2 Wire HD Indoor Station DS-KH7000EY-E2 Release Note(2024-06-24)

Device Model	Firmware Version
DS-KH7000EY-E2	V1.0.0_build240619

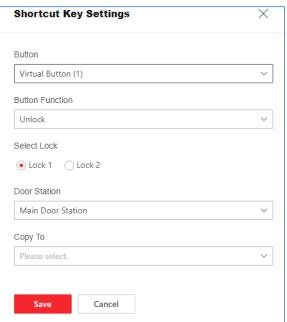
5. Convenient for users to customize functions according to their own usage habits by 4 custom touch buttons. Currently only support customize as unlocking

- a. Setting the custom touch buttons from door station mobile web or pc web.
- b. By default shortcut key 1 for unlocking lock1 of main door station, shortcut key 2 for unlocking lock 2 of main door station, shortcut key 3&4 are empty.
